## CAISO 2020/21 Transmission Plan: Stakeholder Comments

LS Power appreciates the opportunity to submit comments on CAISO's 2020/21 Draft Transmission Plan.

### (1) Economic Study: COI congestion & SWIP-North as an economic project

Figure 1: SWIP-North utilization from ABB study (ABB SWIP-North case)

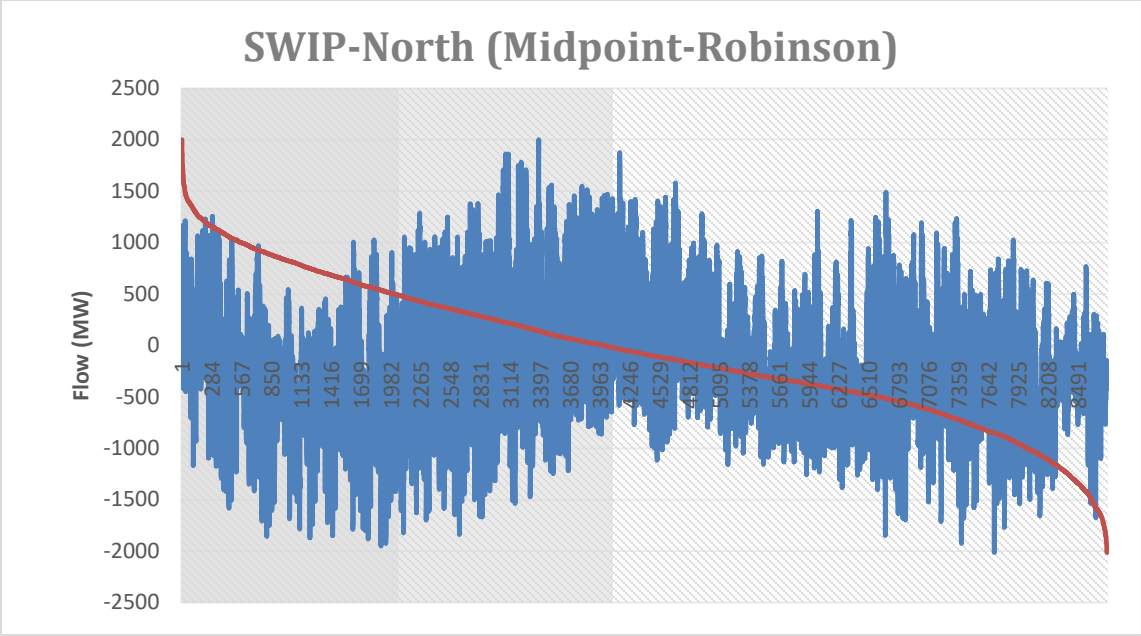
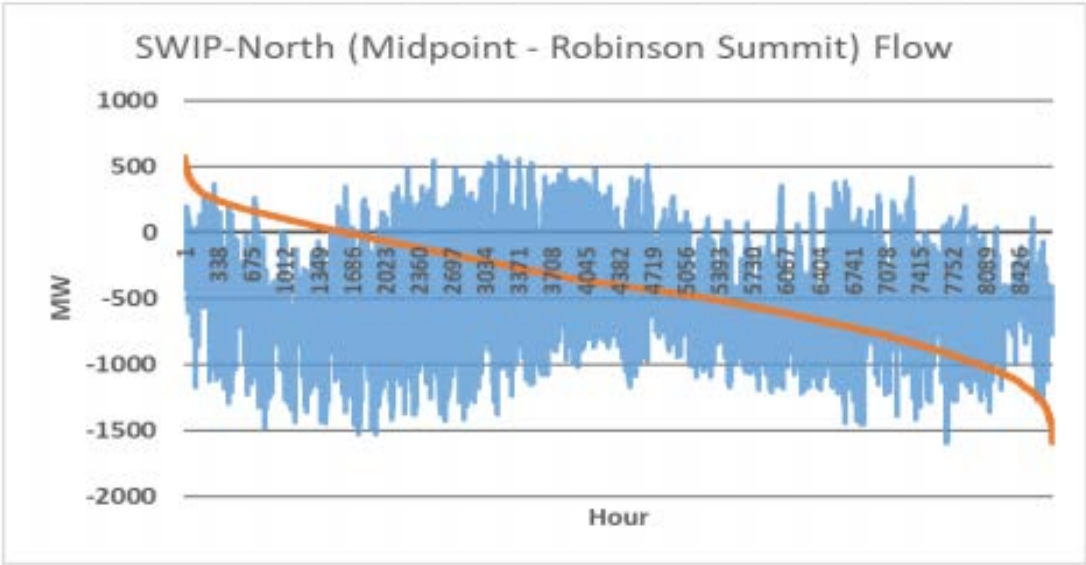
- a) **SWIP-North upgrades should be included** - CAISO should ensure that the existing 500 kV transmission path from Robinson Summit to Harry Allen ("ON Line") is limited to 1000 MW in the base case and is increased to 2000 MW only in the case with SWIP-North. In addition to the new 500 kV transmission line and series capacitors between Midpoint and Robinson Summit, the SWIP-North project also includes key upgrades to existing infrastructure which include the addition of 70% series compensation on ON Line and phase shifting transformers on the existing Robinson Summit-Gonder and Robinson Summit-Falcon 345 kV lines. These upgrades enable increased transfers in the north-to-south (N-S) direction from Midpoint to Harry Allen. It appears CAISO's study did not include these upgrades, resulting in under-utilization of the 2000 MW SWIP-North path in N-S direction (for example, CAISO's study shows line flows not going above 600 MW in the N-S direction).

2. SWIP-North utilization significantly increased as the series compensation on Robinson Summit – Harry Allen effectively reduces impedance of the 500 kV path from Midpoint to Harry Allen. In addition, phase shifters at Robinson Summit effectively push the flows on SWIP-North 500 kV path rather than NVE’s Falcon & Gonder 345 kV system. This is shown in Figures 1 & 2 below. (Positive flows are in North to South direction)

Robinson Summit to Harry Allen series compensation & Robinson Summit phase shifters are key modelling elements & these should be incorporated in CAISO study. Correctly capturing these updates leads to significant increase in utilization of SWIP-North transmission line in N-S and S-N directions. This leads to approximately \$40m to \$70m per year benefits (depending on phase shifter operation), a significant increase from \$10m per year shown in CAISO study.
